IDAP REPORT

Property:	15 Coventry Road STRATHFIELD Lot: 4 DP: 31617 DA2021.87
Proposal:	Demolition of existing structures and construction of a two (2) storey dwelling house with basement, swimming pool, outbuilding, front fence and associated landscaping works.
Applicant:	Swa Group
Owner:	Z Tan
Date of lodgement:	3 May 2021
Notification period:	7 May 2021 to 21 May 2021
Submissions received:	One
Assessment officer:	J W Brown
Estimated cost of works:	\$1,485,000.00
Zoning:	R2-Low Density Residential - SLEP 2012
Heritage:	Adjacent to two (2) heritage items: <ul style="list-style-type: none"> • I127 – 13 Coventry Road • I128 – 17 Coventry Road
Flood affected:	Yes
Is a Clause 4.6 Variation Proposed:	No
RECOMMENDATION OF OFFICER:	APPROVAL

Figure 8: Original Front façade (left) and amended front façade (right)

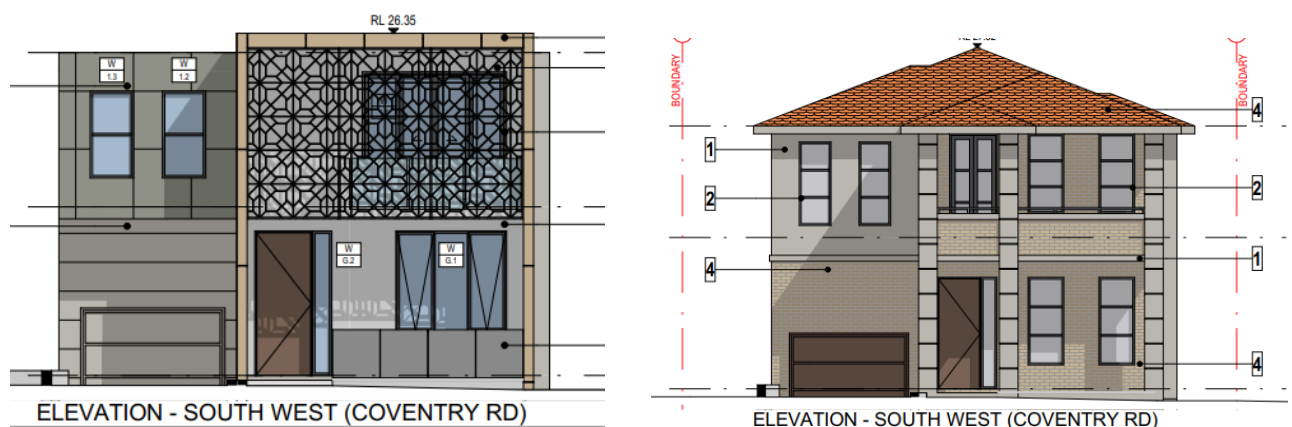
The application was referred to Council's Heritage Officer who requested the following items to be amended on the plans

1. *Change the design so that it includes a pitch roof to meet the heritage DCP controls*
2. *Delete the screen, the metal fabric and replace the glass balustrade to meet the heritage DCP controls. Introduce, colour and material that reflects the surrounding character or the period of the adjoining heritage items rather than having a stark contrasting colour such as the black.*

3. *Redesign the frontage to include windows that reflect the period style of neighbouring dwelling houses. Centre the windows and French doors (in line with the rhythm and pattern of the street) and consider rounded corners on the façade.*

4. *The hard surfaces within the front setback are excessive and not in keeping with the heritage items- look at reducing hard surfaces and increase the landscaping.*

5. *Consider the lowering of the fence and include a top rail.*
6. *The basement carpark ramp is steep and will impact the streetscape. The entrance to ramp needs to be gradual with the entrance further back. This will lessen the visual impact and the required excavation.*

7. *Reduce overshadowing of heritage item at Number 13 Coventry Rd.*

The applicant provided the relevant documentation as well as amending the plans to meet the requested amendments. Council's heritage officer reviewed the relevant documentation and found the proposal to be acceptable subject to conditions of consent.

Most of the recommendations have been incorporated into the final design of the proposed development. A pitched roof has been added to ensure the architectural expression is in keeping with the adjoining heritage items. The design and rhythm of the windows has been improved in the amended scheme.

The use of a hump in the driveway to hide the basement from the street and the introduction of the top rail is also an improvement. The overall height is compliant under the SLEP 2012 but further reduction would will improve solar access and amenity to the neighbouring residences. A condition has been added to reduce the overall height of the dwelling by reducing the ceiling to floor heights of both ground floor and first floor by 200mm (overall

400mm). Further conditions have been added to improve the front façade and to protect the adjacent heritage items.

Figure 10: Basement with calculations of floor space

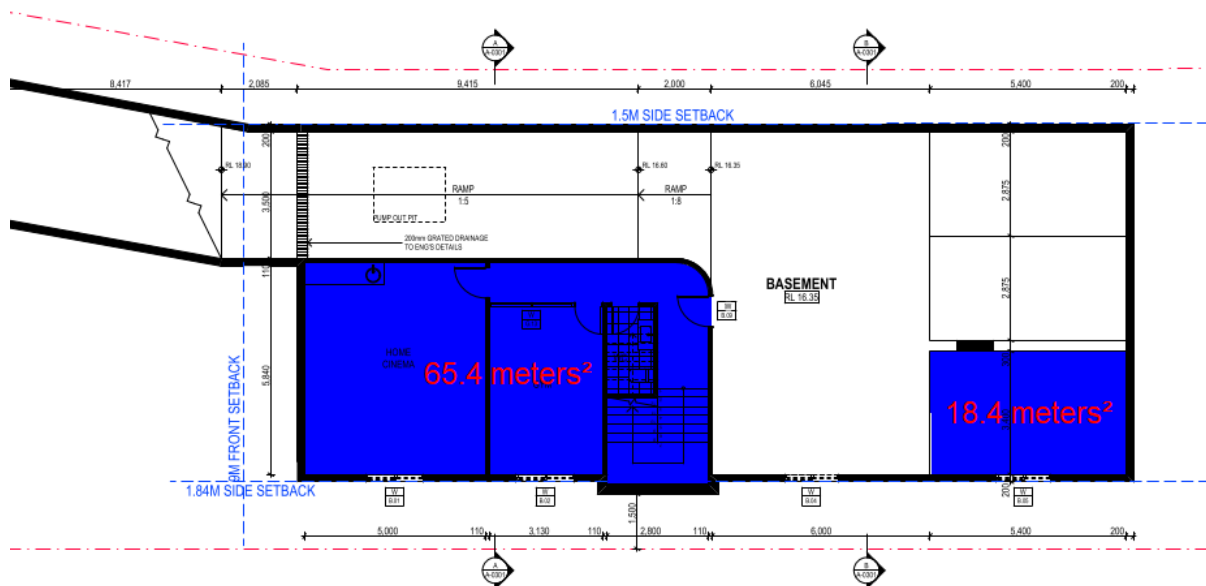
The application was referred to Council's Traffic Manager who offered suggestion that basement could be reconfigured to reduce size. After reviewing the updated plans with a small modification to the basement, Council's Manager for traffic had no objection subject to the conditions of consent.

approved plans	
Privacy Screen Planting	The Landscape Plan shall be updated to provide privacy screen planting abutting the rear boundary to improve privacy to the rear neighbour
Dwelling Height	The dwelling height is to be reduced by 200mm on both ground and first floor. Thereby the maximum dwelling height must be reduced from the proposed RL27.82 to RL27.42 or below.
Driveway width	The vehicular access driveway width must be reduced from the proposed 3.7 metres to 3 metres to achieve a maximum allowed width of 3m at the boundary. The driveway ramp must have maximum width of 3.5m. Any front fence or gate opening adjustments required as a result of this reduction must be illustrated on the plans lodged with the application for the Construction Certificate.
Rear Balcony	The rear balcony must be reduced so that it is no more than 1m in depth by 2m in length
Basement Height	The basement clearance height must be no more than 2.2m.
